COLLETON PLACE SUBDIVISION

APPLICATION NUMBER 30 DATE October 18, 2007

DETAIL SITE PLAN

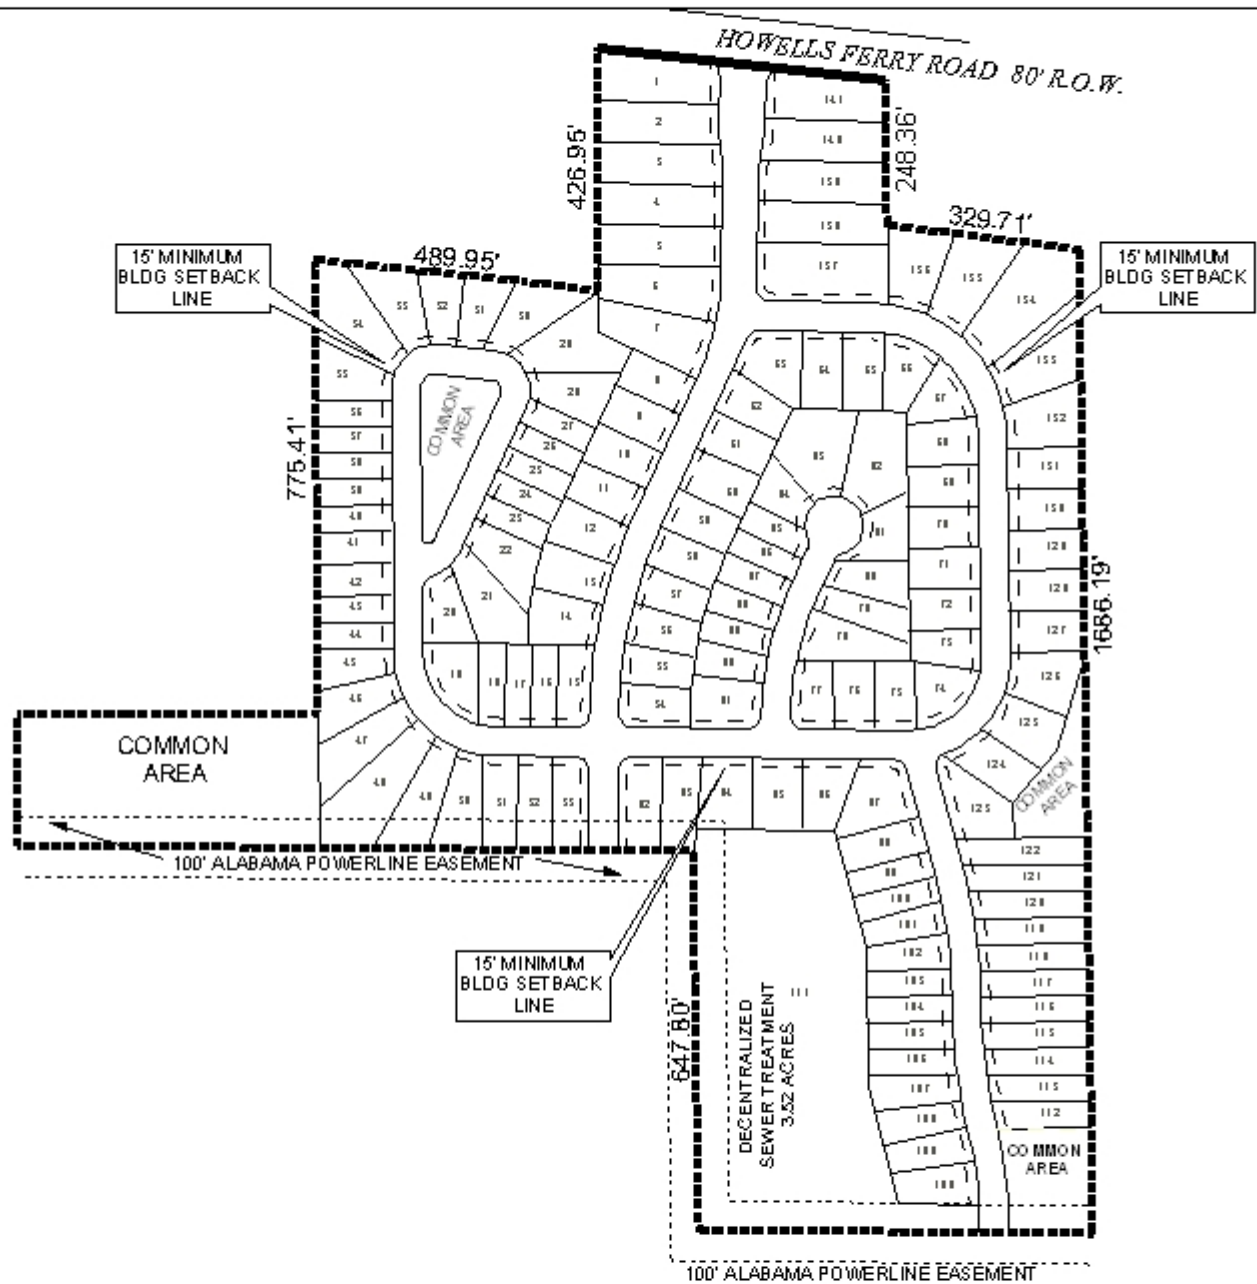
The application proposes a new street, which must be constructed and dedicated to Mobile County Engineering standards prior to signing the Final Plat. Lots 1, 15, 53, 54, 63, 74, 77, 91, 92, 97, 137, and 141 are corner lots; therefore, a note should be placed on the Final Plat limiting each lot to one curb cut each, with the size, design and location to be approved by County Engineering.

It appears that many of the lots do not comply with Section V.D.2. of the Subdivision Regulations; therefore, if approved a waiver of V.D.2. would be required.

No lot sizes in square feet were indicated on the plat; therefore the final plat should be revised to label each lot with its size in square feet, or a table depicting the same information should be provided.

Common areas are proposed within the subdivision and a decentralized sewer treatment area is labeled but no specifics were submitted. It should be noted that the common areas on the east and west of the proposed subdivision have no detailed easement or access illustrated on the preliminary plat.

Stormwater detention facilities are not depicted on the plat. While the site is located in the county, compliance with the City of Mobile stormwater and flood control ordinances will be required. A letter from a licensed engineer certifying compliance with the City's stormwater and flood control ordinances should be submitted to the Planning Section of Urban Development prior to the signing of the final plat, if approved.

- 1) the placement of a note on the Final Plat limiting Lots 1, 15, 53, 54, 63, 74, 77, 91, 92, 97, 137, and 141 are corner lots; therefore, a note should be placed on the Final Plat limiting each lot to one curb cut each, with the size, design and location to be approved by County Engineering;

- 2) revision of the plat to meet the minimum lot size requirements contained in Section V.D. of the Subdivision Regulations, or provision of a statement justifying the request for reduced lot sizes and setbacks;

- 7) labeling of all lots with size in square feet, or placement of a table on the plat containing the lot size information;
- 8) the provision of an easement to all common areas; and

- 9) the submission of a letter stating the compliance of Section V.D.2. of the Subdivision Regulations prior to the signing of the Final Plat or documentation from the developer stating the location and design of a centralized sanitary system to handle the wastewater of the subdivision
